CITY OF CONWAY, ARKANSAS HISTORIC DISTRICT COMMISSION

August 24, 2020 · 5:30pm · Conway Municipal Building · 1111 Main Street

Old Conway Design Overlay District

I.A

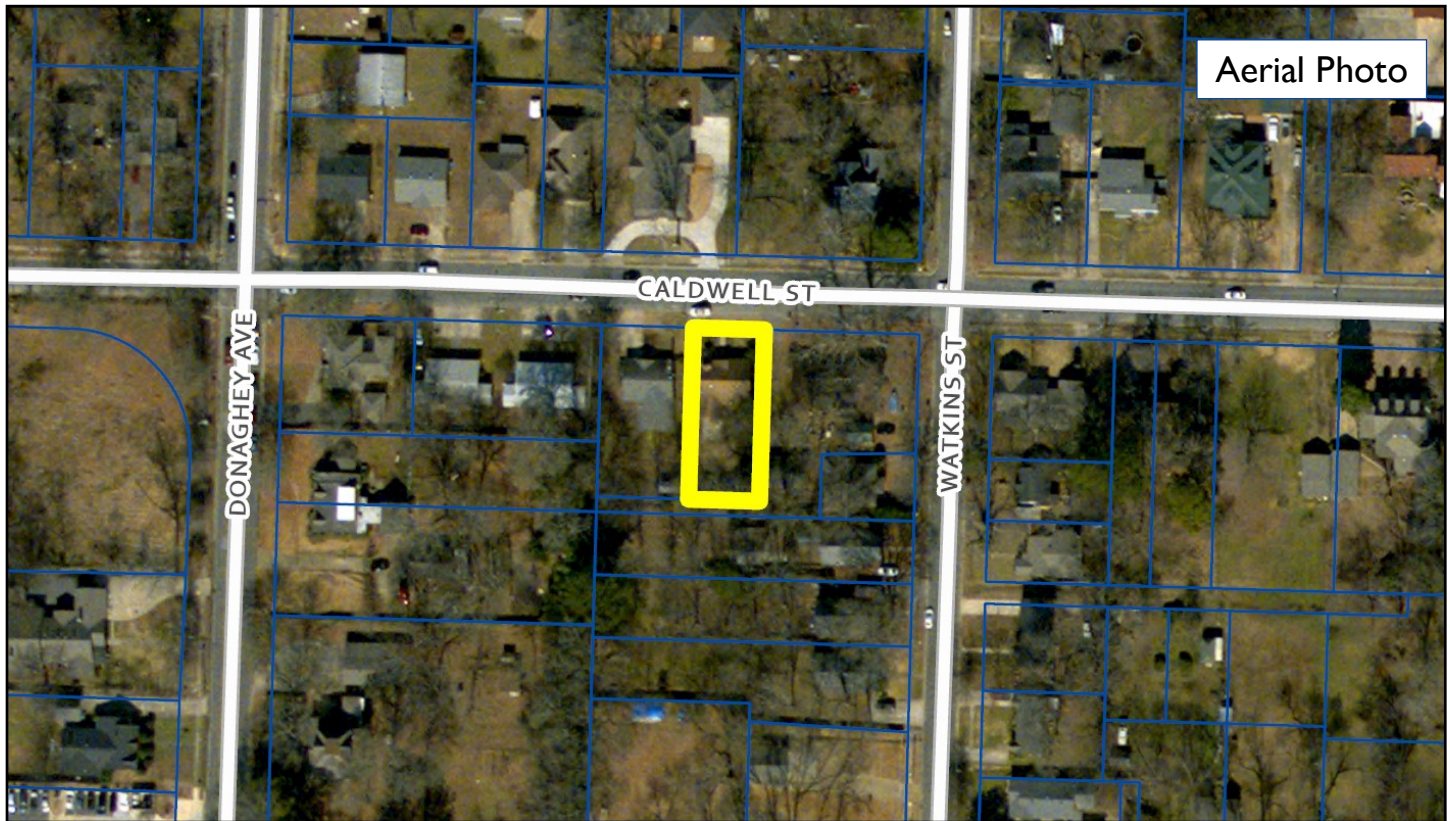
General Description of Property and Proposed Development. The site is occupied by a single-family home in a Folk Victorian style. The house has a footprint of 2,450 sf with an existing accessory building which has a footprint of 890 sf. The applicant is proposing to remodel the existing accessory building by reconstructing the roof and supporting roof structure on the front 19.5' of the approximately 42.5' accessory building. The existing barn style roof would be replaced with a roof pitch to match the back half of the structure.

The structure will feature a gable roof that is compatible in design and pitch to the roof of the principal structure.

The applicant will clad the structure in Hardieboard siding with detailing compatible to the primary structure.

1. All mechanical equipment shall be placed in a manner to minimize view from the right-of-way or adequately screened.

Front Elevation

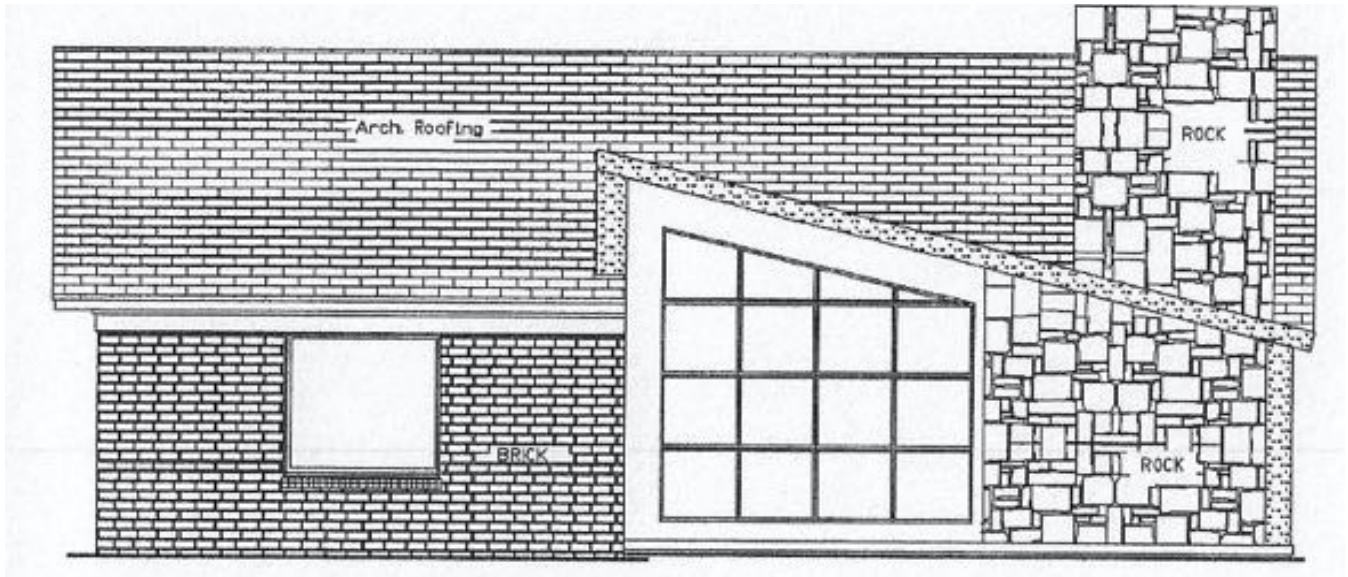
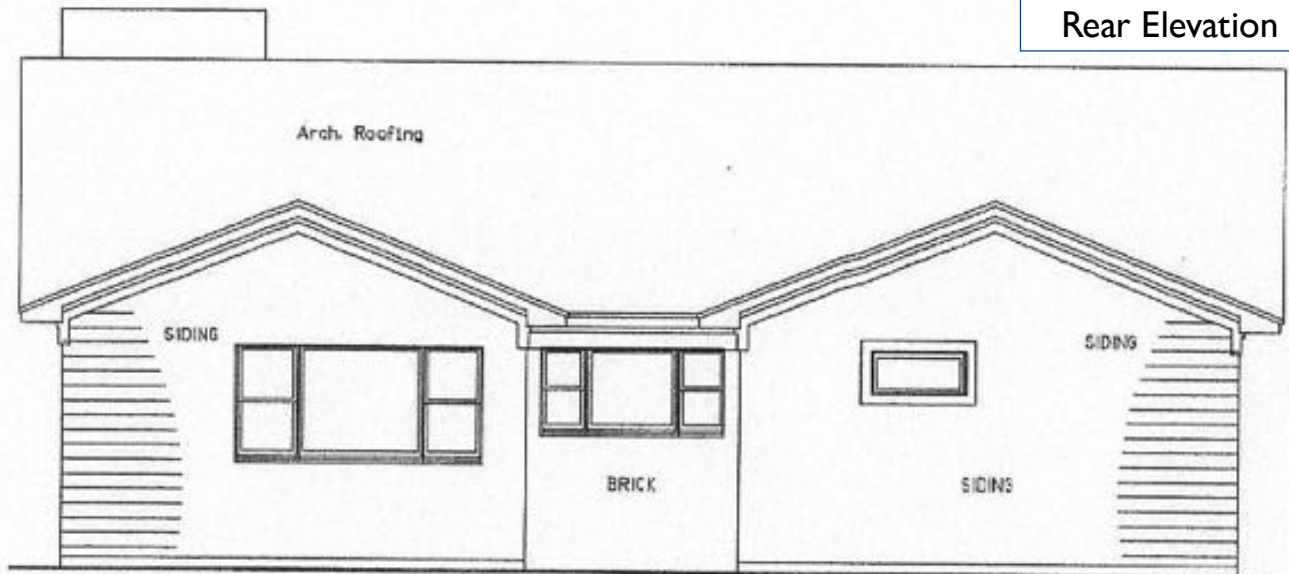
The majority of the existing structures in the area have simple forms as it pertains to massing and articulation. The existing roofline of the house is asymmetrical and is proposed to remain. The proposed removal of the iron columns would simplify the front façade, making the structure more consistent with the other homes in the area.

While the existing porch has a width less than 6 feet, the applicant is not proposing to increase the non-conformity. The applicant is proposing to replace the iron columns with wood and construct a wall at the west end of the porch.

The applicant is proposing to replace an existing aluminum window on the right side of the house as well as the front door. Staff has recommended a condition of approval that the new window be true divided light or 1 over 1 in style.

1. Materials which are consistent with the existing structure shall be used for the addition.
2. The new columns shall be of a wood material and a minimum of 8"x8".
3. Sidewalk in lieu fees shall be paid for the full length of the Caldwell St frontage.
4. The window to be replaced on the right elevation shall be true divided light or be 1 over 1.
5. One canopy tree shall be planted in the front yard to replace the tree being removed.

West Elevation

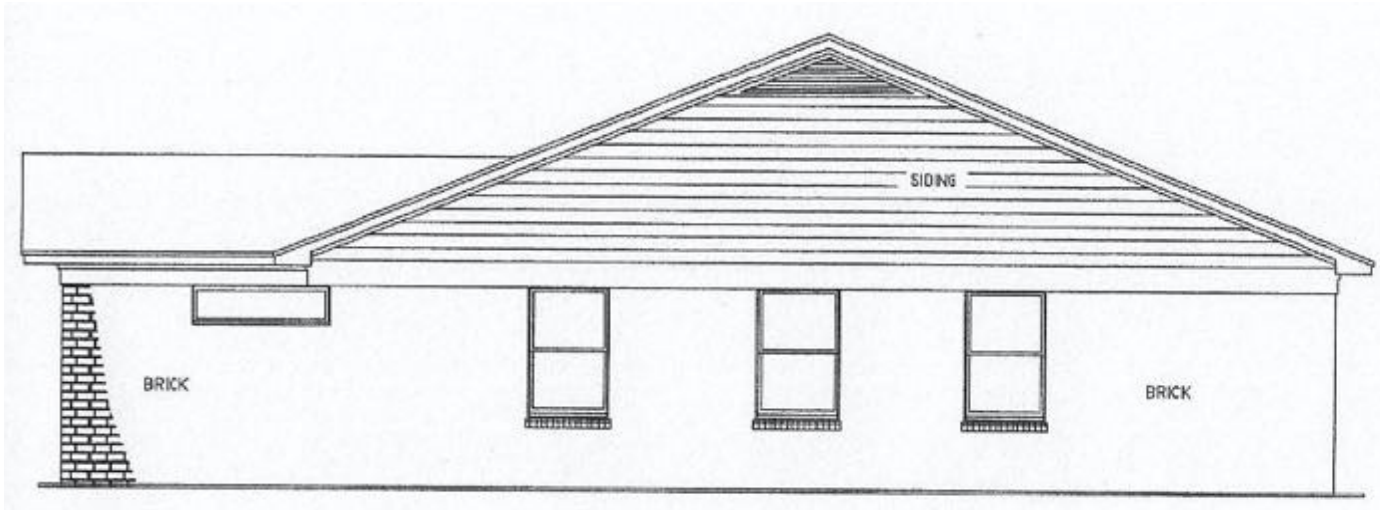
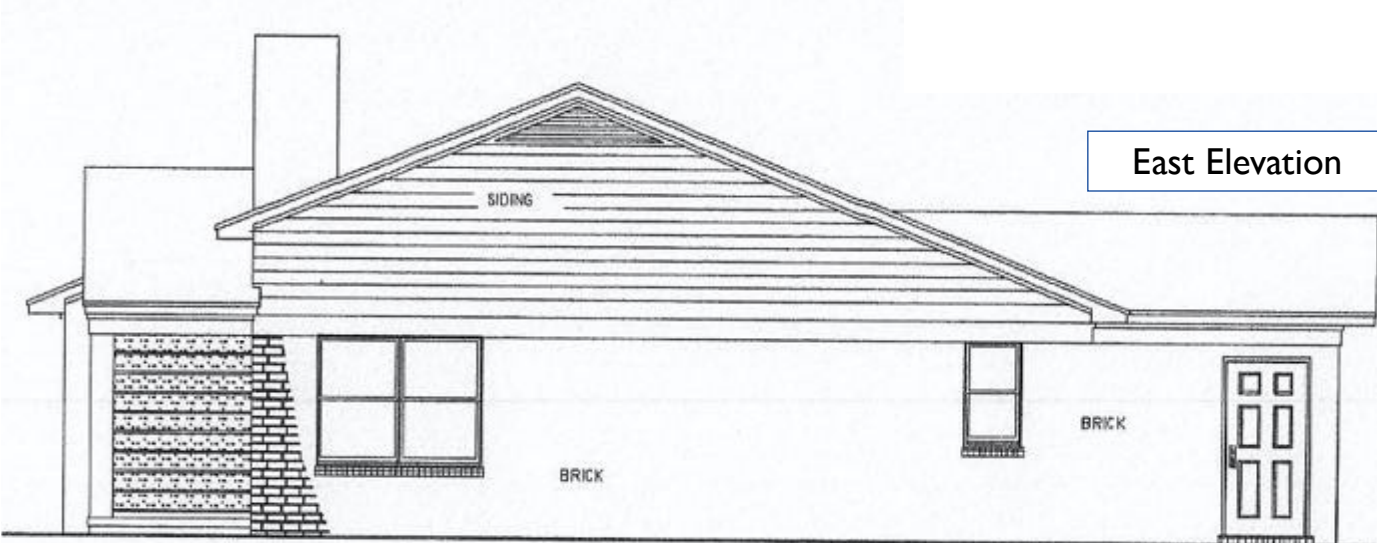
The proposed addition is located at the rear of the existing house and will not be visible from the public right of way. The applicant is proposing to use matching siding as exterior cladding if available or wood/Hardie siding.

I.C

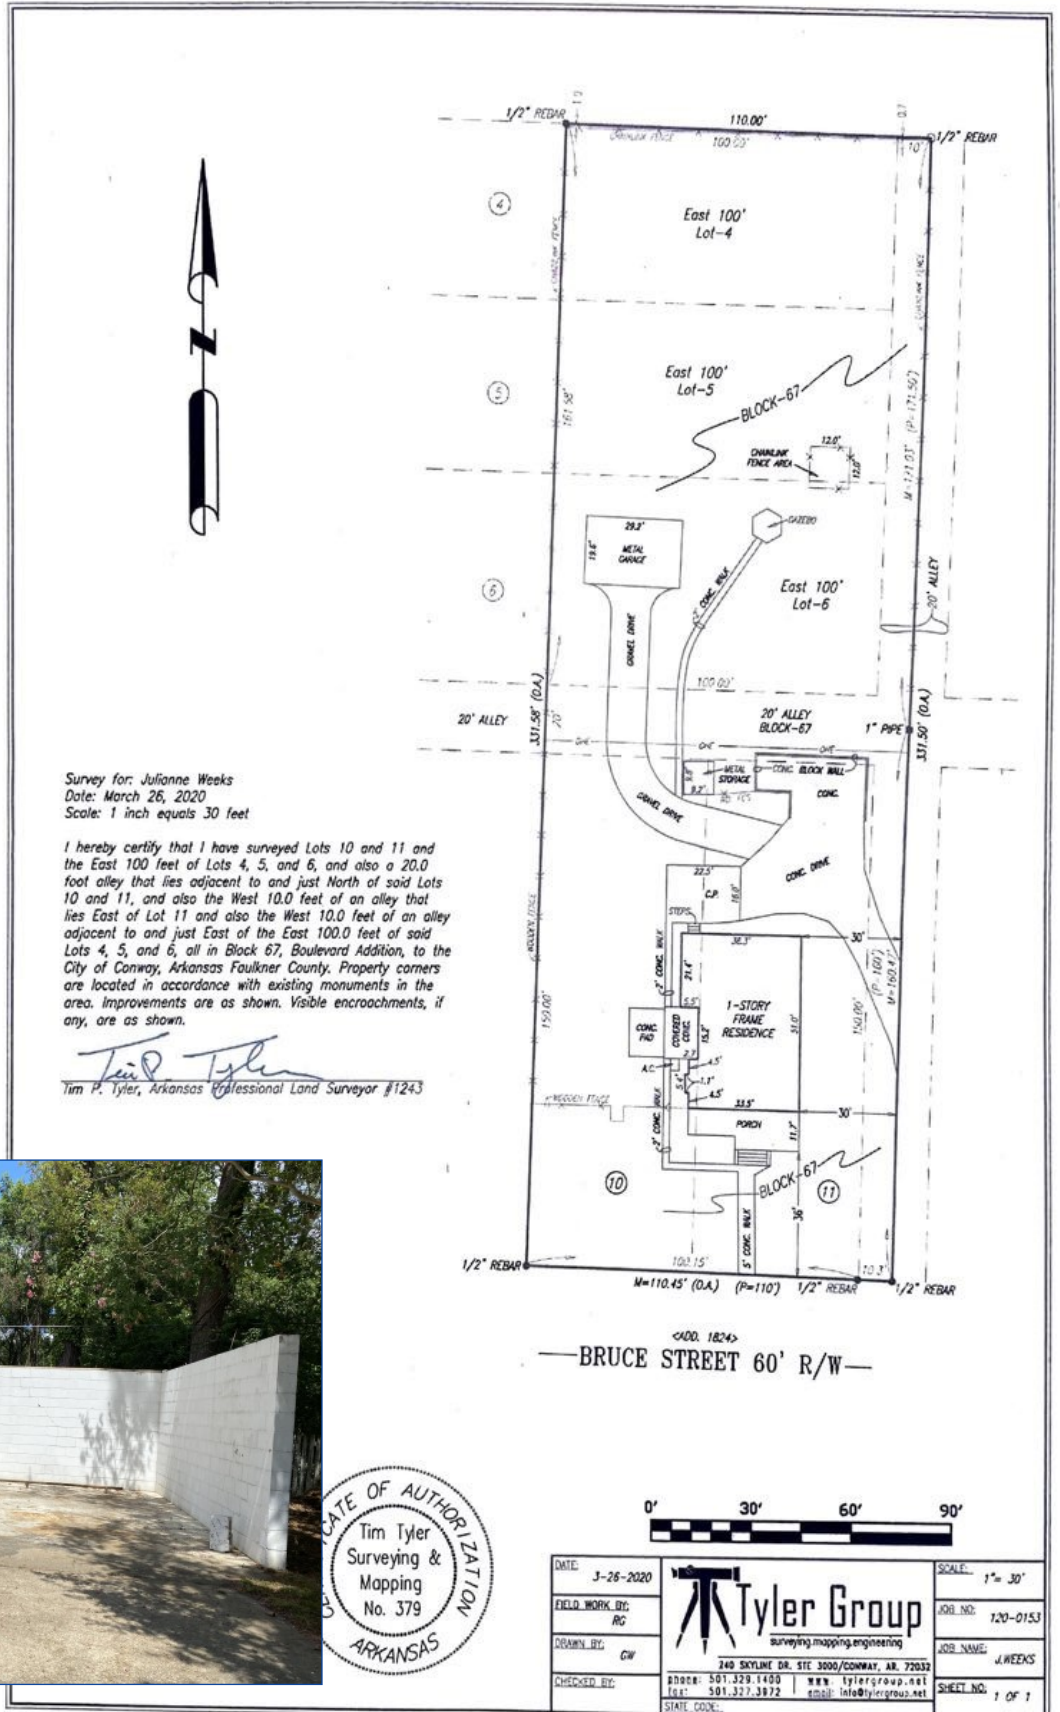
The applicant is proposing to relocate the front door by approximately 2 feet. The existing door is proposed to be used in the new location. Additionally, the applicant is proposing to replace 9 windows at the side and rear of the house. Currently, the applicant is proposing replacement windows featuring simulated divided lights which are discouraged in the OCDOD guidelines. Staff has recommended a condition of approval that windows use true divided lights and window materials be compatible with those traditionally found in Old Conway.

The applicant is proposing to remove existing aluminum siding on areas of the house to reveal existing wood siding. Where wood siding is in disrepair or absent the applicant is proposing replacement wood or Hardie siding.

1. Materials for the addition shall be used that are consistent with the materials of the existing structure. Wood or Hardie siding is acceptable.
2. 5-foot sidewalks shall be constructed along the Bruce St frontage or sidewalk in lieu fees shall be paid.
3. The windows to be replaced shall be of a material compatible with those traditionally found in Old Conway and shall feature true divided lights.

RIGHT ELEVATION

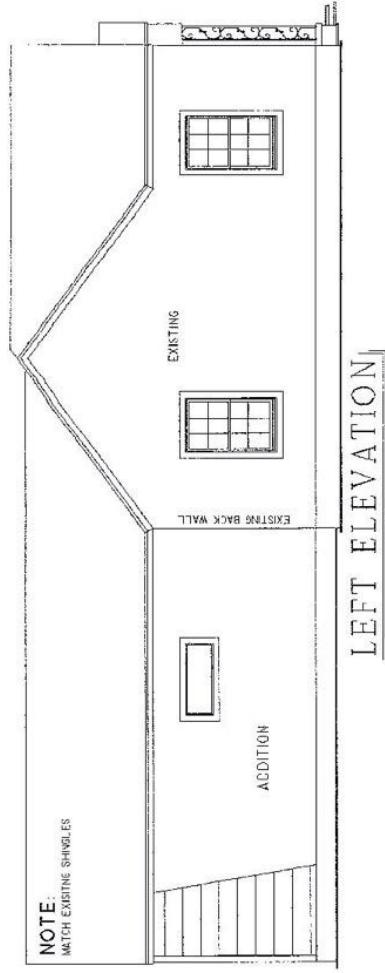
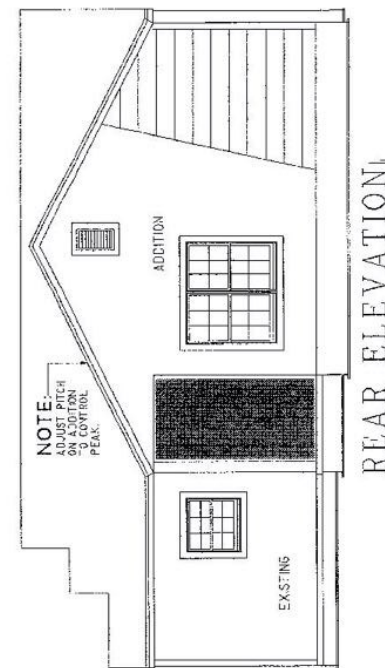
All new windows and any replaced windows must feature true divided lights windows. Vinyl windows must be 1 over 1 windows.

The applicant has not specified a material to be used for cladding. The existing home is vinyl siding. Recommend requiring a wood equivalent material such as Hardieboard or LP SmartSide for cladding.

The addition will be placed at the rear, inset and at a lower height than the existing structure, It is designed in a manner to make it secondary and compatible.

1. Planting of one canopy tree in the rear yard, if any tree over 8" is removed.
2. Require true 1 over 1 windows for all windows replaced and all windows on the rear addition.
3. Require fascia and soffits to be finished with wood or wood equivalent construction such as Hardieboard.
4. HVAC equipment be placed in a manner to minimize its visibility from the street.

I.F

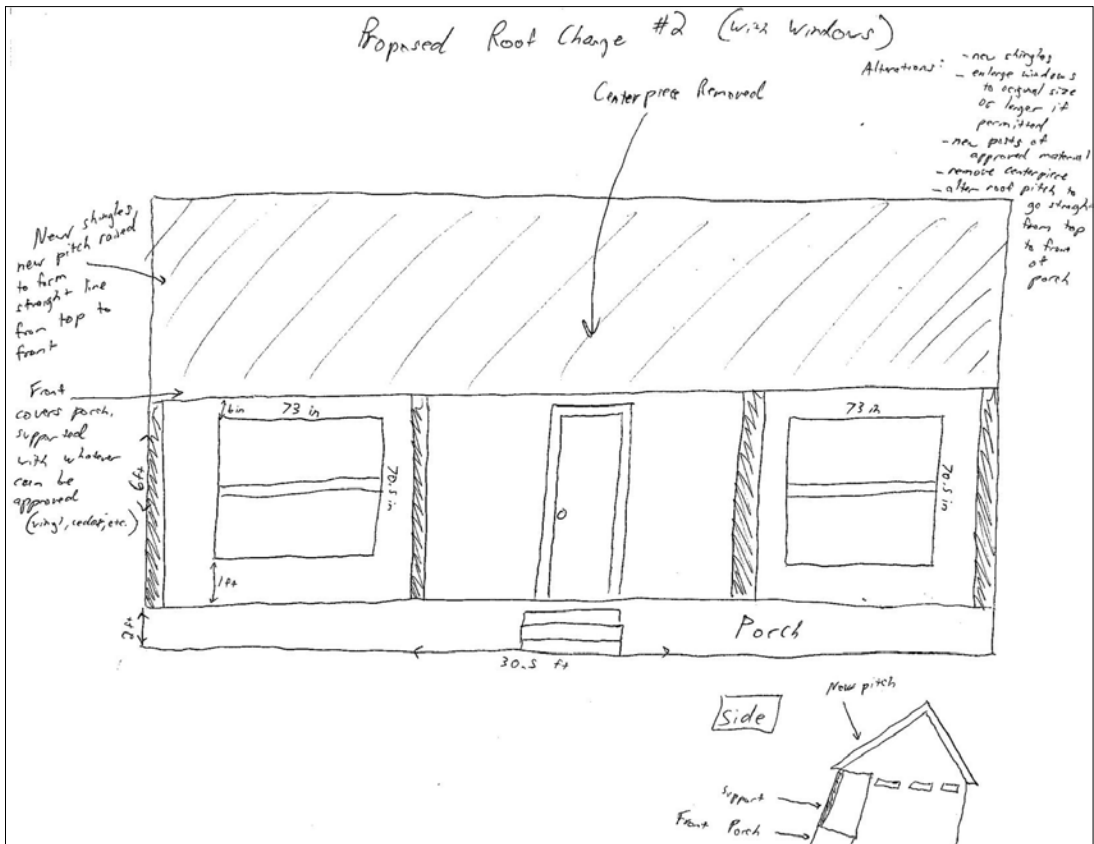
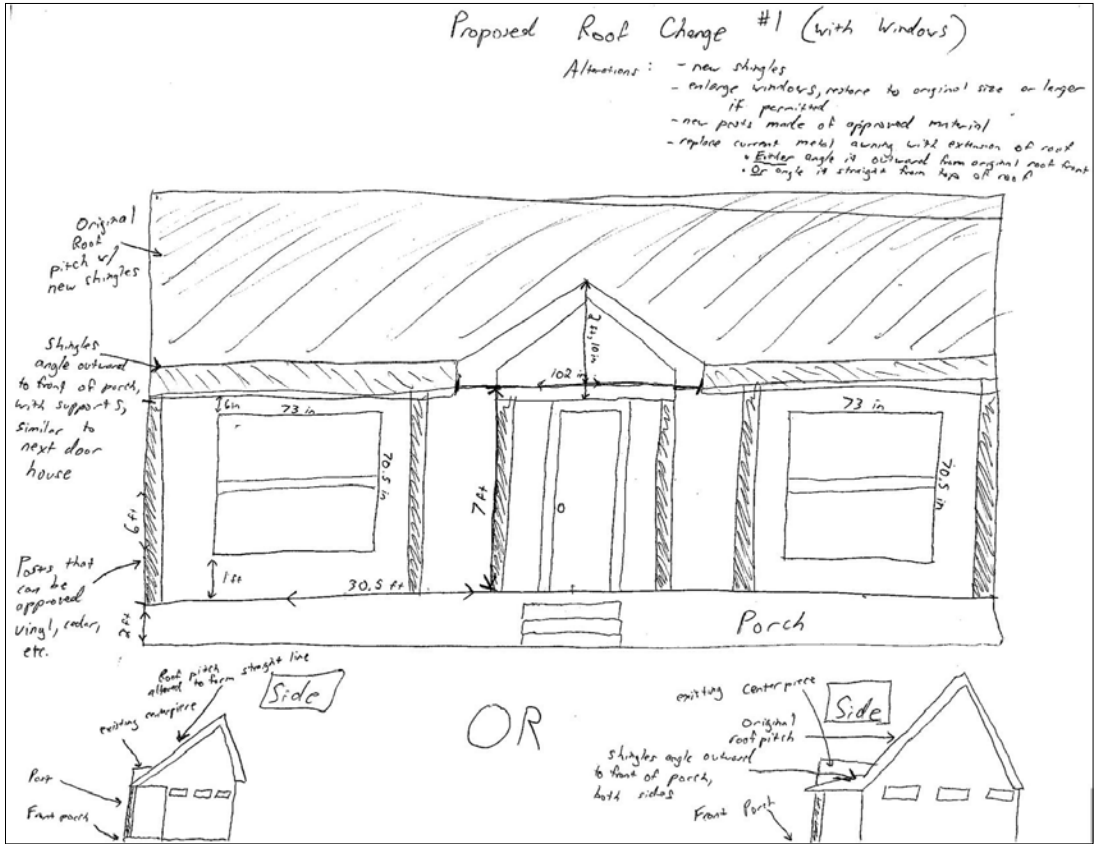
The majority of the existing structures in the area have simple forms regarding massing and articulation. The existing roofline of the house is symmetrical and proposed to remain. It is Staff's opinion, that only option 1 would maintain the existing complexity of form while option 2 would remove features that provide articulation to the front façade. The proposed replacement of the iron vertical supports would correct the current disproportionate feel.

The applicant is proposing two options with regard to the porch modifications. It is Staff's opinion that only option 1 would keep the existing character of the house while also remaining compatible to the prevailing design of the area. The existing metal awnings are not compatible with the building materials used elsewhere on the house. As such, the proposed change will bring the structure into conformance with OCDOD guidelines.

The applicant is proposing to restore the existing 62"x20" window openings to the original 73"x70" dimension. Staff has recommended a condition of approval that the window material be compatible with those traditionally found in Old Conway which are typically some form of double-hung sash.

1. Option 1 shall be implemented with regard to the roof and porch modifications.
2. The new columns shall be of a wood material and a minimum of 8"x8".
3. New windows at the front of the house shall be of a material compatible with those traditionally found in Old Conway which are typically a form of double-hung sash.
